# UNITED STATES PATENT AND TRADEMARK OFFICE

APPLICATION NO.	FILING DATE	FIRST NAMED INVENTOR	ATTORNEY DOCKET NO.	CONFIRMATION NO.
10/669,971	09/24/2003	Nathan A. Winslow	5490-000337	4885

# Office Action Summary

## **DETAILED ACTION**

Main (fourth) drawing of the BIOMET brochure shown below:

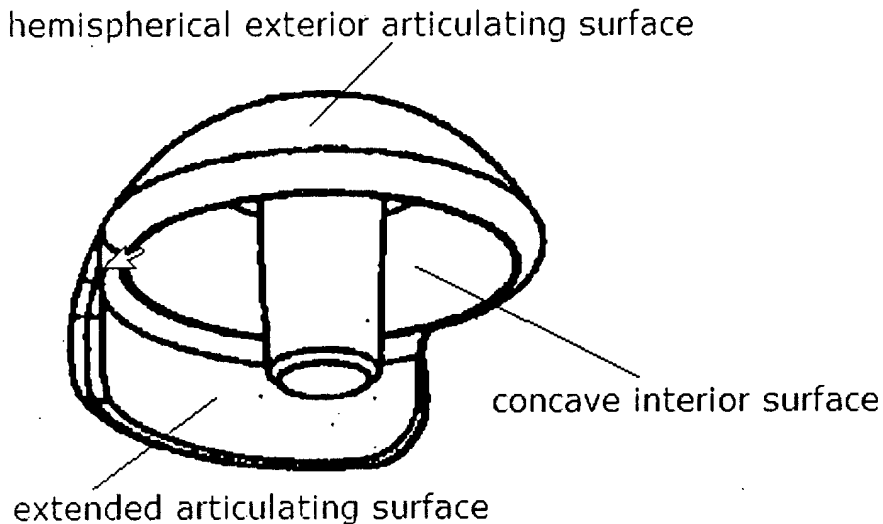
7. Claims 1-3 and 6-10 are rejected under 35 U.S.C. 102(b) as being clearly anticipated by BIOMET brochure (engineering drawings submitted 7/22/1997, and cited in Applicant's IDS of 12/17/2003).

Referring to Drawings 1-4, the BIOMET brochure disclose a resurfacing humeral implant comprising:

- (i) A hemispherical exterior articulating surface;
- (ii) A concave interior surface opposite said exterior articulating surface;
- (iii) An integral (i.e., unitary) straight, tapered anchoring device (see drawings) having a textured outer surface (brochure disclosed it as a glass bead blast), said anchoring device extending from said interior surface; and
- (iv) An extended articulating surface protruding from a portion of said hemispherical exterior articulating surface. The second (i.e., lateral view) and fourth (i.e., main or fourth) drawings shows the extended articulating surface as comprising a "step".
